Wivenhoe Town Council / C-BUS (Peter Kay) - Matter 6 Hearing statement - Transport.

Because of the significant changes to / revelations about the 'East' RT and link road proposals suddenly introduced by ECC in the Autumn 2019 Public Consultation document, this Hearing Statement is largely concerned with the questions that these 'new' aspects raise.

APPENDIX 2

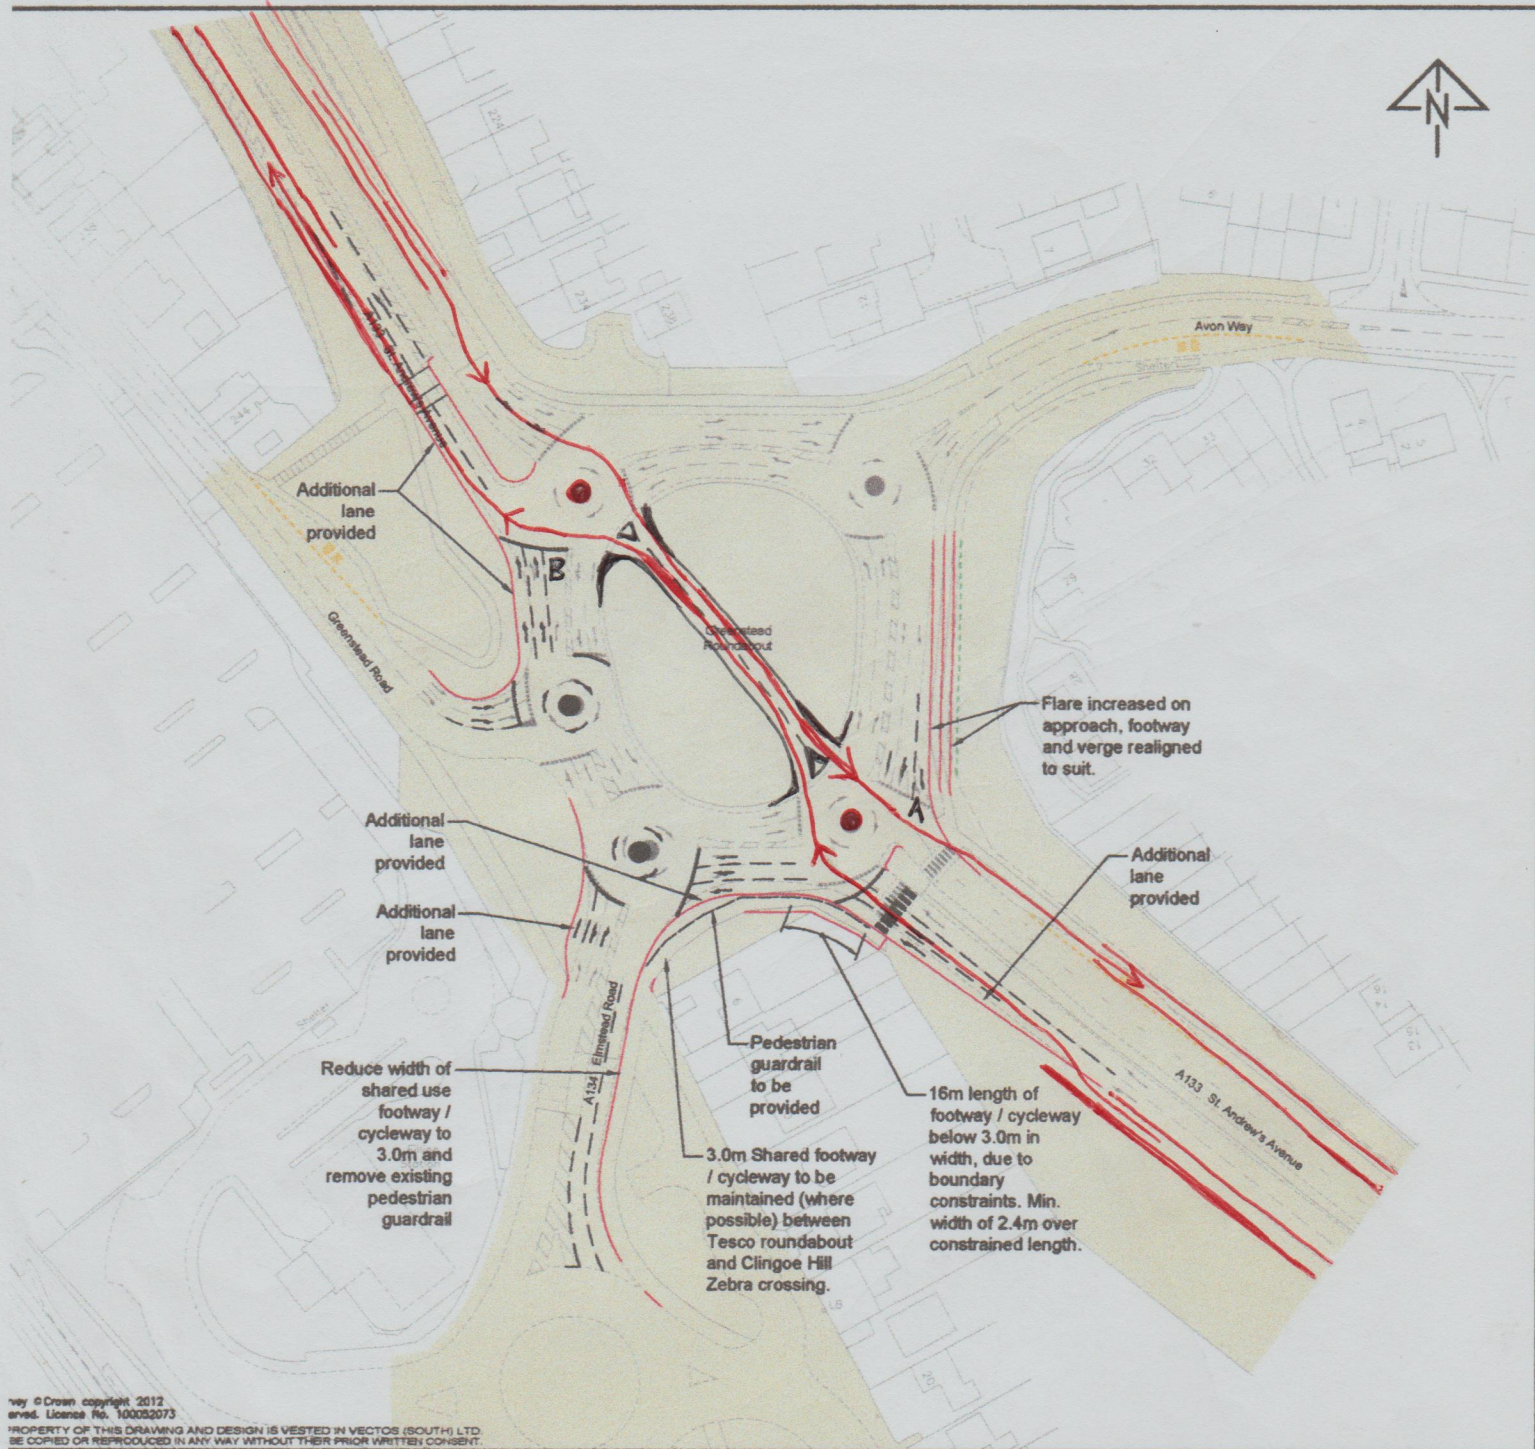
'It is proposed to create two lanes that run directly through Greenstead roundabout, dedicated to RTS vehicles, running east-west. This section will have to be carefully designed / modelled in order to reduce the hazards associated with 4-arm mini-roundabouts'.

However it is actually clear what is being proposed from the reference to *4-arm* mini-roundabouts (the mini-roundabouts all being 3-arm currently, as normal with 'magic roundabouts'); and they could have produced a sketch plan very quickly had it been desired to let current roundabout users know what is proposed. As they have not done so, I have done one myself (**attached as Appx 2**), with a caption explaining what the new hazards would be. (Let them produce *their* version if they claim that this is *not* what they mean!).

The scheme, as the internal report notes, results in the roundabout being turned into a 'throughabout'; but 'throughabouts', like our own example at North Station, are generally *fully-signalled* and therefore safe.

What appears to be proposed for Greenstead roundabout in Option 5. The particular 'hazards' to be introduced are that drivers at stop lines A and B would not only have to watch 60-90 degrees to the right (as currently) for gaps in the traffic emerging from the previous entrance, but also simultaneously check 120 degrees to the right in case a bus suddenly emerges from the middle of the roundabout with priority over them.
